UNITED STATES
NUCLEAR REGULATORY COMMISSION
REGION II
101 MARIETTA ST., N.W., SUITE 3100
ATLANTA, GEORGIA 30303

Report Nos. 50-269/82-28, 50-270/82-28, and 50-287/82-28

Facility Name: Oconee

SUMMARY

Figure-1
Photograph depicting general view of steam turbine heat extractor pipe elbow where failure occurred. The point of failure appears to be near the 12 o'clock position. The torn pipe section is folded under the pipe.

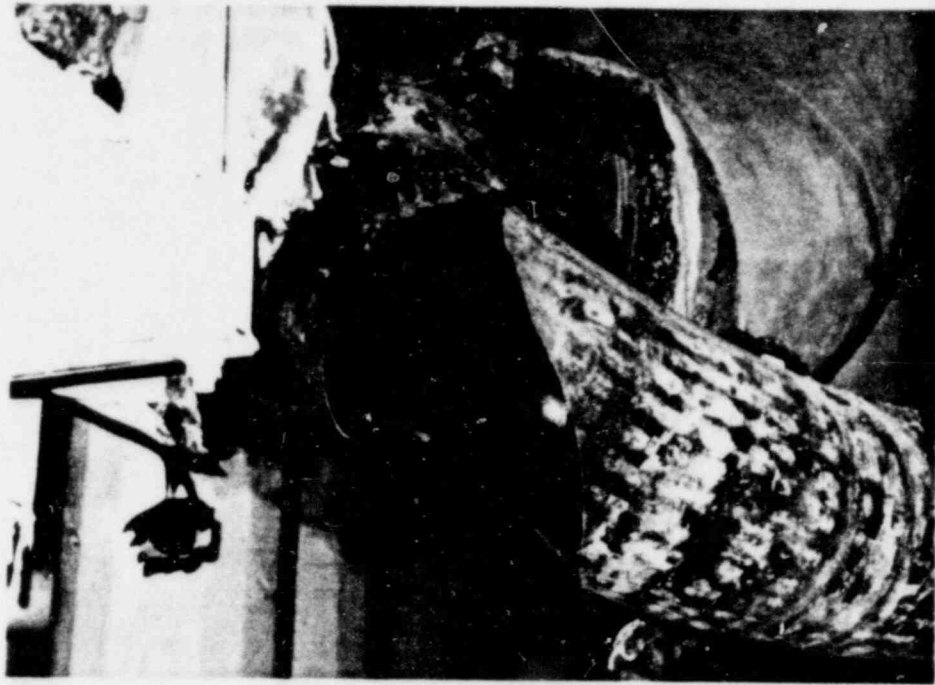
On June 28, 1982, the first 24-inch elbow down stream of the 42-inch high pressure discharge pipe turbine end left side C-extraction line ruptured (see figures 1 and 2). The inspector observed the failed component section that was located in the turbine building and noted that the work effort to replace the failed section had been completed.
